ST. MARY'S COUNTY GOVERNMENT

AMENDMENT OF SOLICITATION		1. CONTRACT NUMBER	PAGE 1	OF PAGES 14
2. AMENDMENT NUMBER 006	3. EFFECTIVE DATE 29 MAY 2025	4. REQUISITION NUMBER 140112	5. PROJECT NO. (If applicable)

14. DESCRIPTION OF AMENDMENT OR MODIFICATION				
<p>This Amendment provides answers to the final round of questions. No additional requests will be entertained.</p> <p>Marked up drawings attached to the end of this Amendment are provided for informational purposes only.</p> <p>The Bid Due Date for Sealed Bids is extended until <u>Wednesday June 11, 2025 at 3pm.</u></p> <p>All other terms and conditions remain unchanged.</p> <p>Except as provided herein, all items, terms and conditions of the document referenced in item 9A or 10A, remains unchanged and in full force and effect.</p>				
15A. NAME AND TITLE OF SIGNER (Type or print)		16A. NAME AND TITLE OF CONTRACTING OFFICER (Type or print) Brandon Hayden, CPP, CPPM, CGPP Procurement Manager		
15B. CONTRACTOR/OFFEROR BY (Sign & Date)		16B. ST. MARY'S COUNTY BY (Sign & Date)		
(Signature of person authorized to sign)		(Signature of Contracting Officer)

ST CLEMENTS ISLAND MUSEUM CONSTRUCTION
Solicitation # 25-DPWT-140112 (QA#4)

1 SECTION DETAIL 1
1 1/2" = 1'-0"

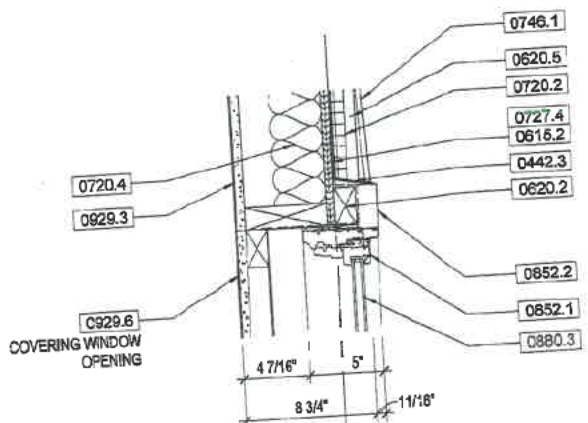
87	Q	The Hunter Cool Vent Panel does not show a 7" R-30 panel, see attached. I have inquired, see answer back from them. See attached two (2) pages. From Hunter, looks like it may add another layer of plywood, please confirm. (1)
	A	<i>No. Per Hunter's response, the R-30 value is achieved via a 2-layer system. The bottom layer is insulation only; and does not add an additional layer of plywood.</i>
88	Q	Would Insulspan Structural Insulated Panel be an approved equal? See attached two (2) pages. (2)
	A	<i>No, Insulspan SIP panels are not an equal product on their own as they do not provide the ventilation portion of the specified Hunter Cool-Vent product.</i>
89	Q	The blocking shown on roof detail at end of rigid insulation. What is the size of the 2X required? (3a) What is the framing at end of the insulated panels? It scales approximately 15". (3b)
	A	<i>2x blocking at end of nailable insulation panel to be 2x4 min to provide attachment along open edge of roof vent.</i> <i>2x blocking along eave to be built up to provide sufficient height to support 16" fiber-cement board trim.</i>

2 SECTION DETAIL 2
1 1/2" = 1'-0"

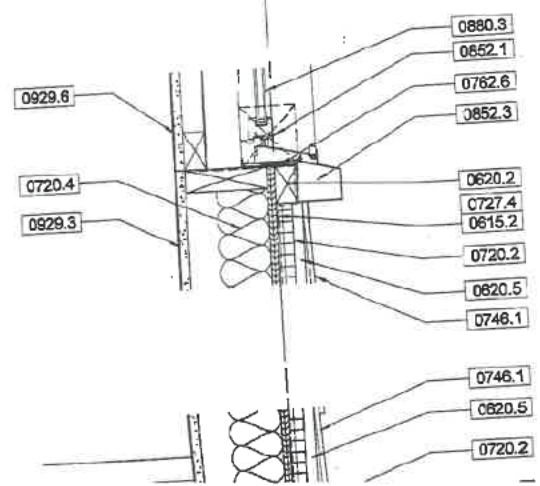
90	Q	What is the 2X furring nailing to? And what is furring size to be? Looks like it should be going perpendicular. (4)
	A	<i>2x furring for cement board soffit vent panels to attach to underside of roof truss extensions.</i>
91	Q	What is the blank space to be? Wood? Blocking? If so, what is it attached to? (5)
	A	<i>Space noted as #5 in sketch provided is an open area for ventilation between the wood blocking noted above.</i>
92	Q	Does 5/8" plywood get any moisture barrier applied to top side? (6)
	A	<i>No</i>
93	Q	Addendum 5 - Question 75 asked about alternate manufacturers for the shades. The answer indicated that substitutions will not be considered during the bid process. There are only two shade manufacturers that can produce the shades on this project, especially the 294" tall motorized shade in the stairwell. MechoShade, which is listed as the specified manufacturer has had price increases due to the tariffs and will not guarantee their pricing for more than 120 days.

E106

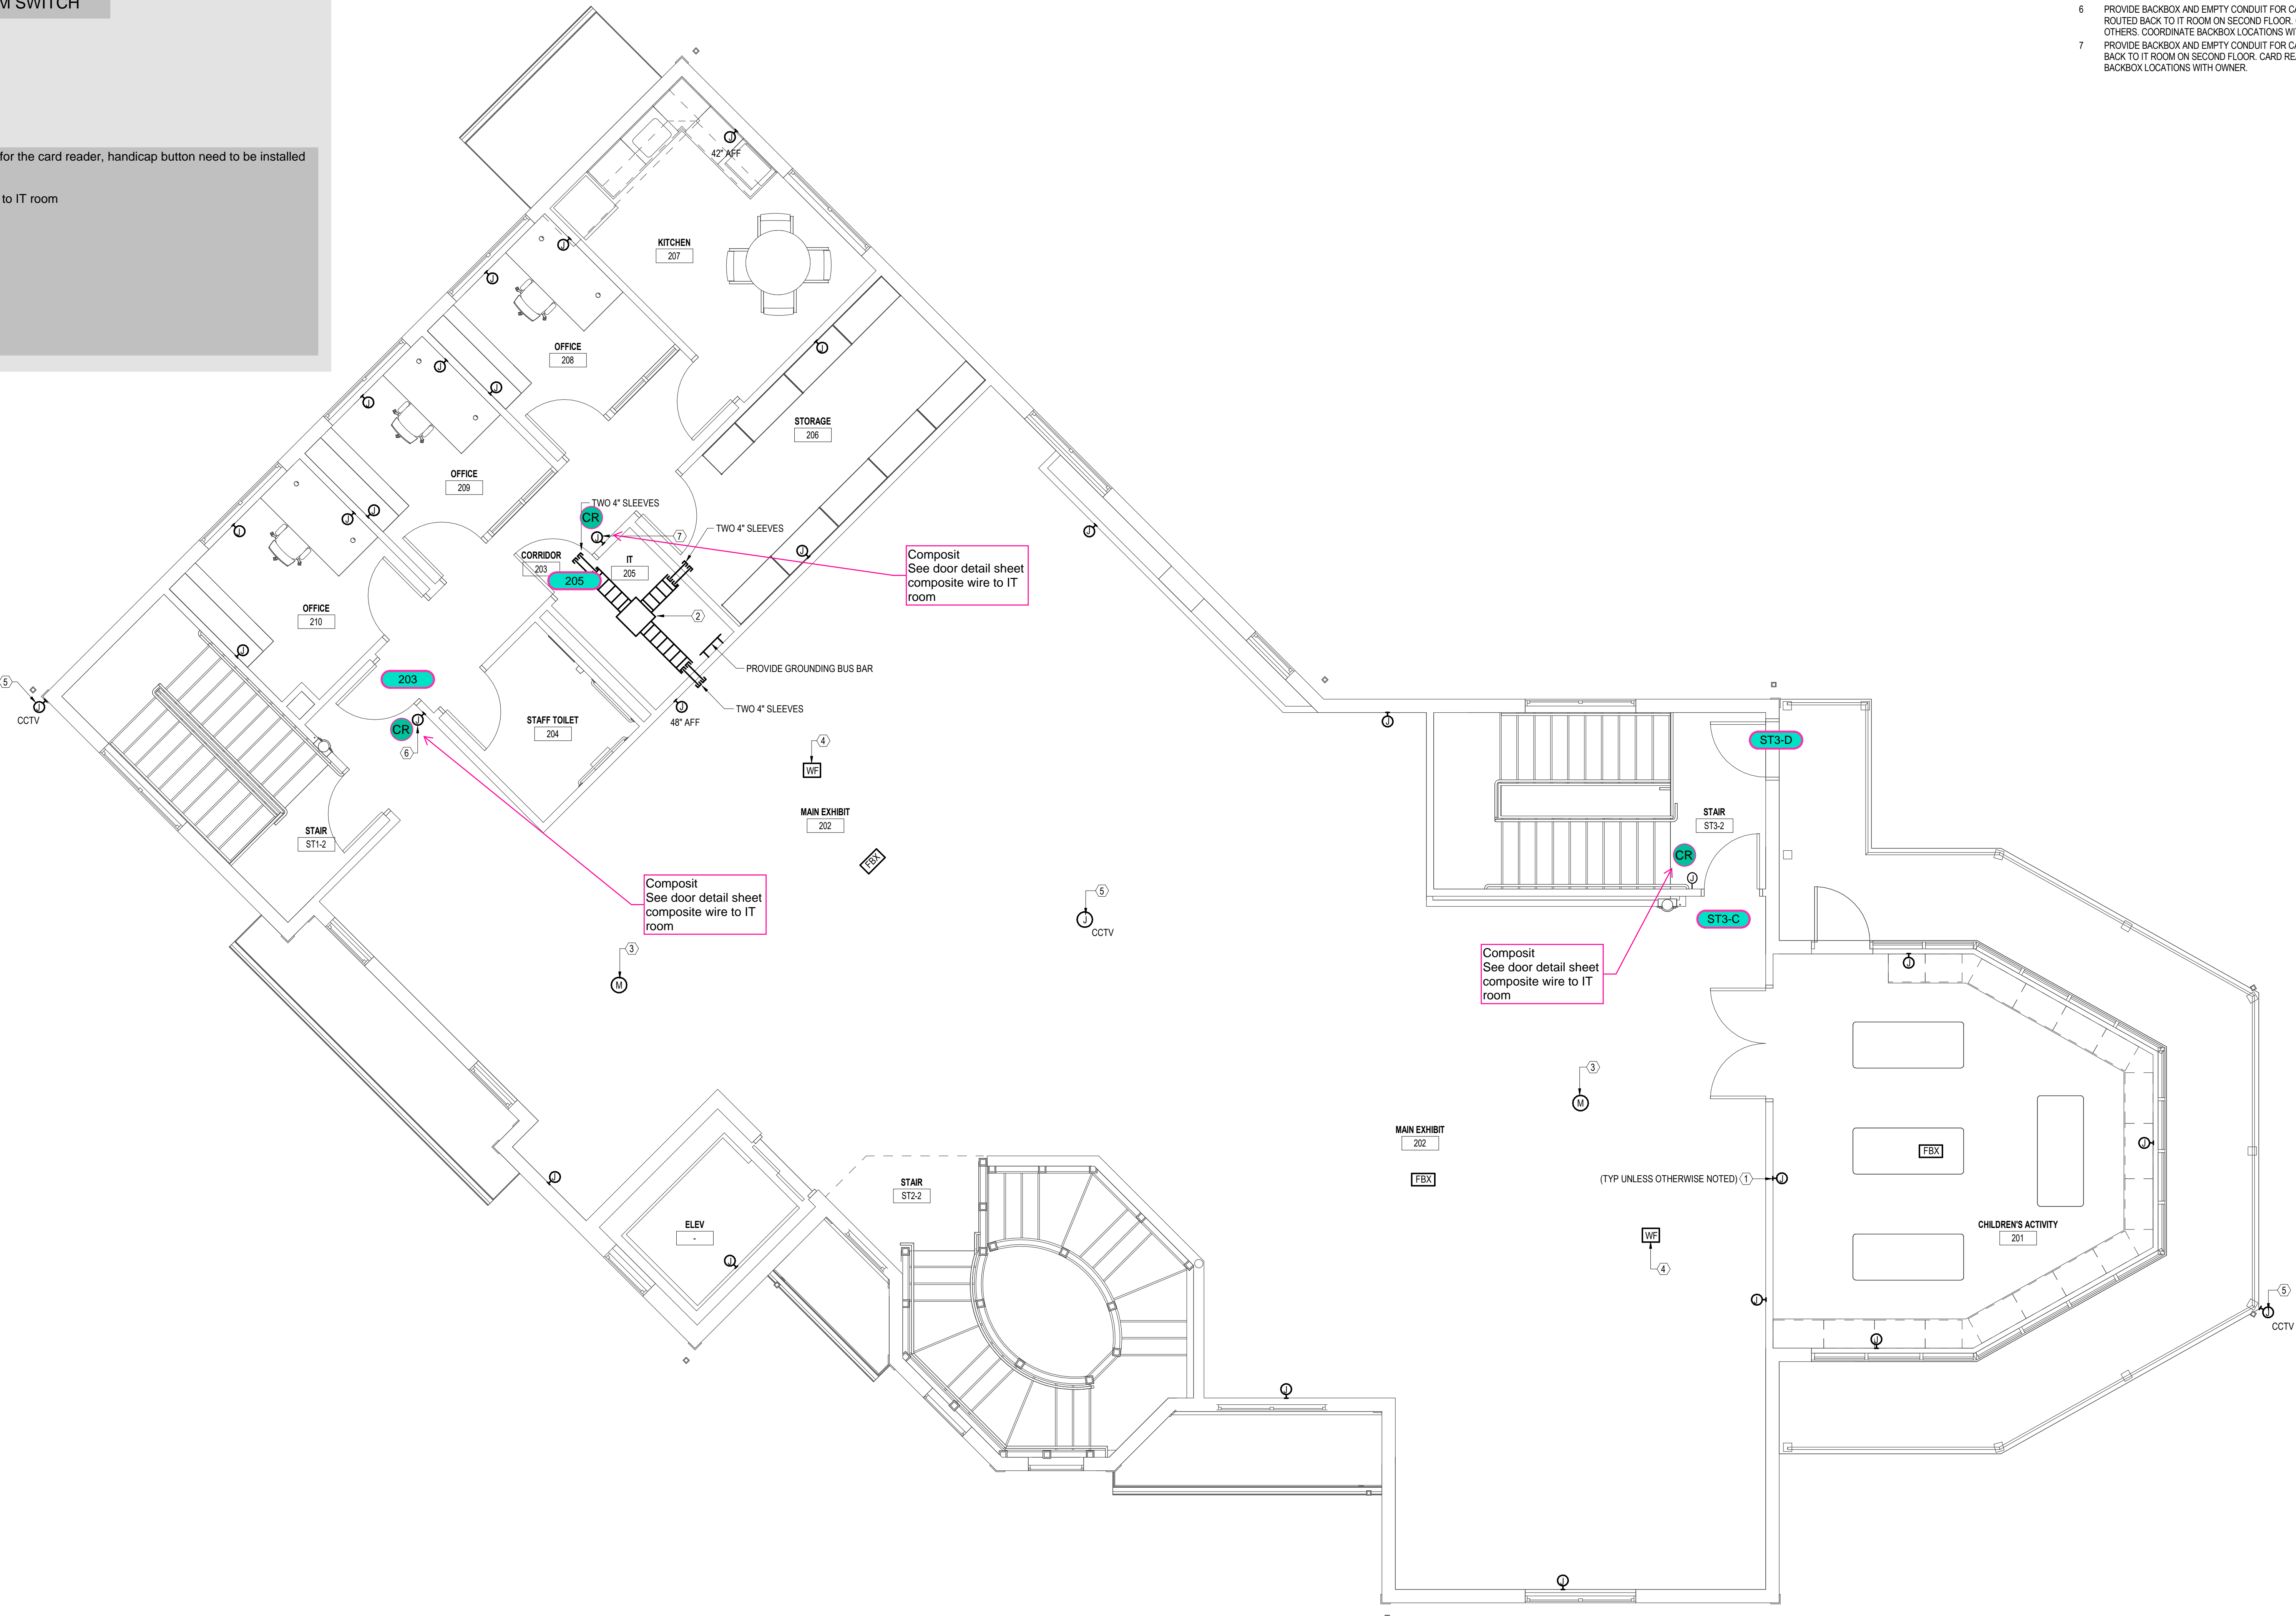
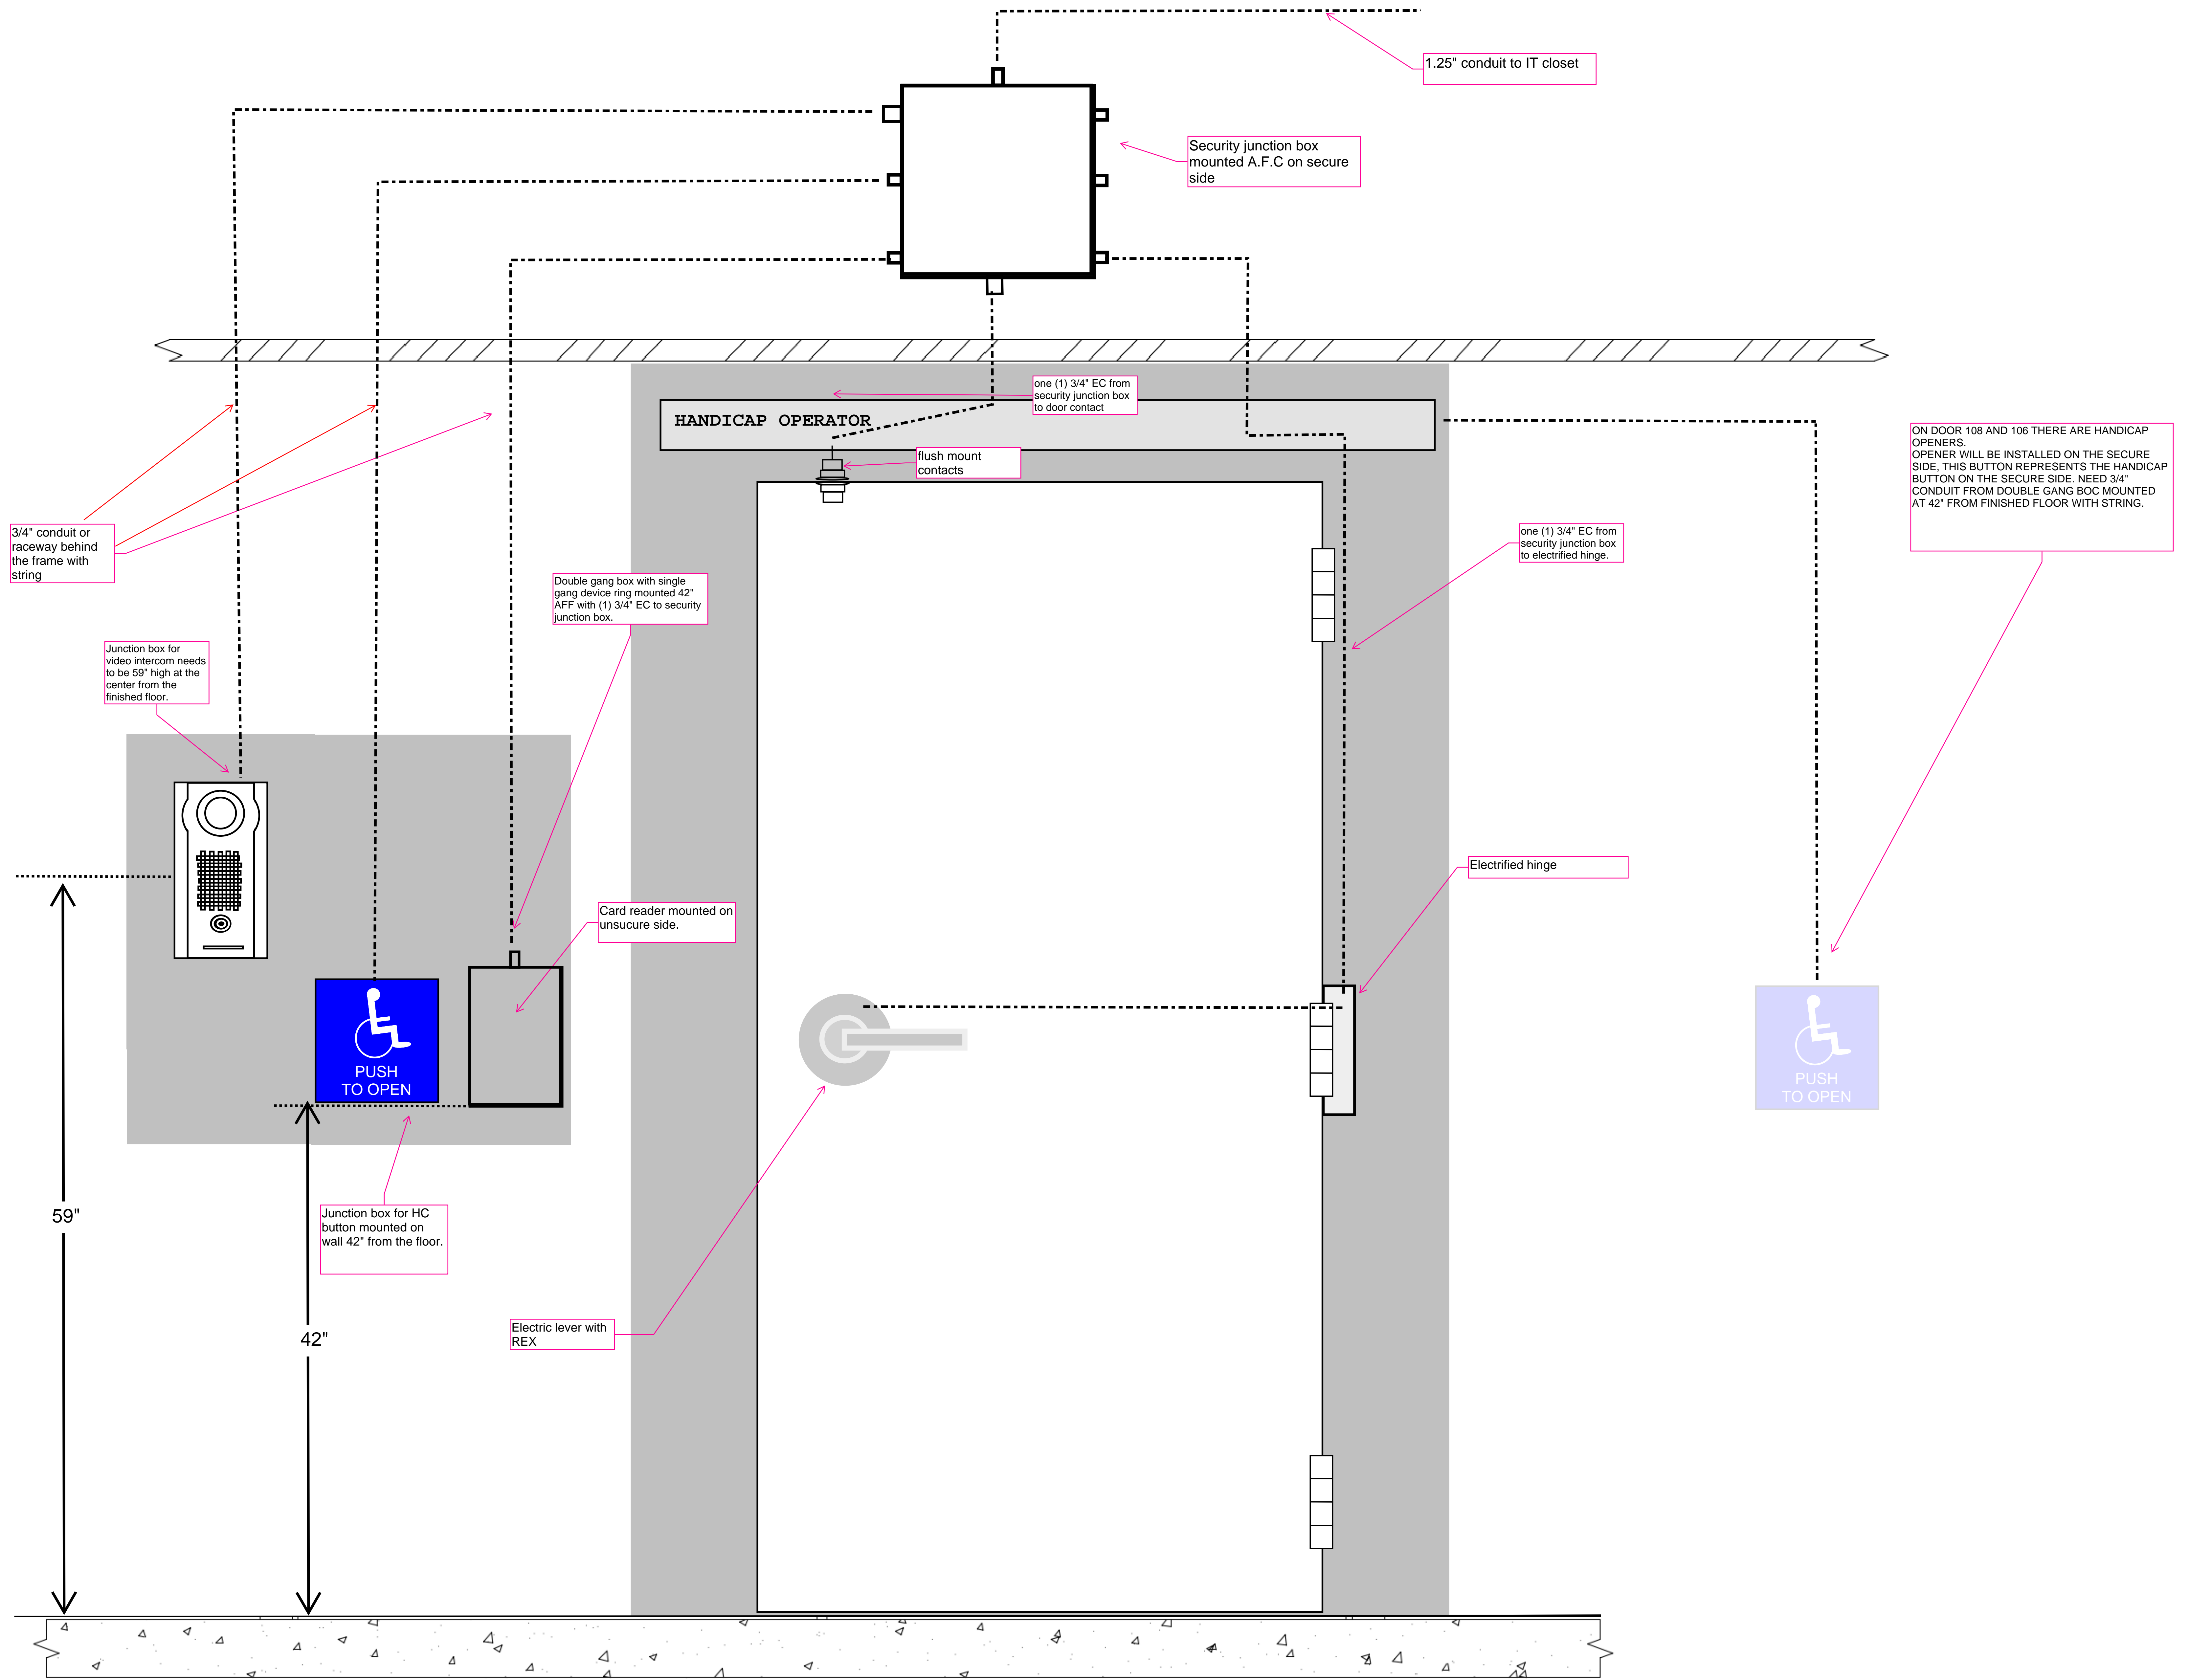
The back boxes need to be installed for the card reader, handicap button need to be installed 42" from the finished floor.
1.25" conduit from each access door to IT room

1.25" conduit to IT closet

Junction box for video intercom needs to be 59" high at the center from the finished floor.

ON DOOR 108 AND 106 THERE ARE HANDICAP OPENER. OPENER WILL BE INSTALLED ON THE SECURE SIDE, THIS BUTTON REPRESENTS THE HANDICAP BUTTON ON THE SECURE SIDE. NEED 3/4" CONDUIT FROM DOUBLE GANG BOC MOUNTED AT 42" FROM FINISHED FLOOR WITH STRING.

A	<p><i>Disregard the notation for ET-003. No ET drawings will be provided.</i></p> <p><i>Crest Lock has provided preliminary drawings indicating the dimensions and requirements for back boxes installing their equipment. Crest Lock will be contracted directly by the Owner during the Commissioning Phase. All conduit to these boxes to be installed by Contractor with labeled pull strings. Wiring to Crest Lock products to be provided and installed by Crest Lock.</i></p> <p><i>Provide labeled ethernet cables with corresponding faceplates to junction boxes assigned to Keynote 1 on E105 & E106.</i></p>
--	----------	---
